Subject: MHI's Responses to US-APWR DCD RAI No. 367-2419 Revision 1

Responses to Request for Additional Information No.367-2419
Revision 1

RAI NO.: NO. 367-2419 REVISION 1
SRP SECTION: 18 - HUMAN FACTORS ENGINEERING
APPLICATION SECTION: 18.8 PROCEDURE DEVELOPMENT
DATE OF RAI ISSUE: 5/14/2009

QUESTION NO. 18-44

Figure 5.8.X Operating Procedure maintenance and control of updates

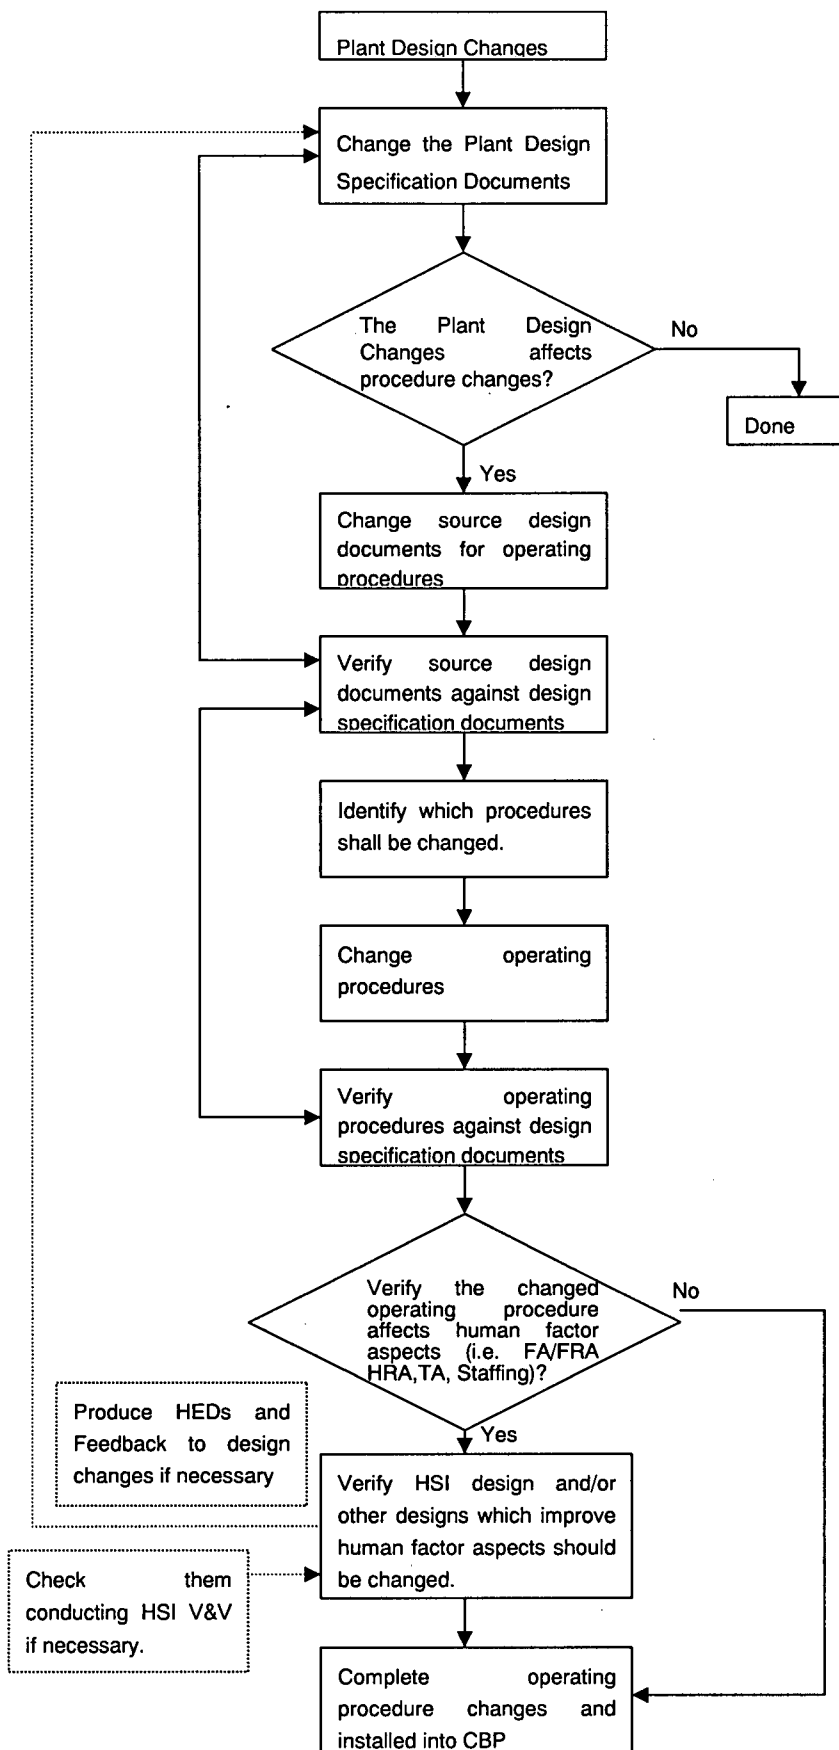
Section 18.8.3 of the US-APWR DCD mostly restates the criterion in NUREG-0711 and does not demonstrate, with sufficient detail, **how** criterion 8 of NUREG-0711 section 9.4 will be met. The staff believes that information to meet this criterion should:

- Provide complete process descriptions
- Provide a flow diagram, or similar graphic example, that illustrates the relationship of the different process steps to each other (if applicable)
- Contain a description of the applicable technical requirements with sufficient quality, to enable the staff to verify that the product conforms to the intent of the methodology

Please provide detailed information to satisfy criterion 8 of NUREG-0711, section 9.4.

Procedure changes may be initiated due to improvements in operating or maintenance methods, or due to plant design changes. Regardless of what initiates the need for a procedure change, the procedure change process described above applies. Figure 5.8.X shows the interaction between the plant design change process and the procedure change process.
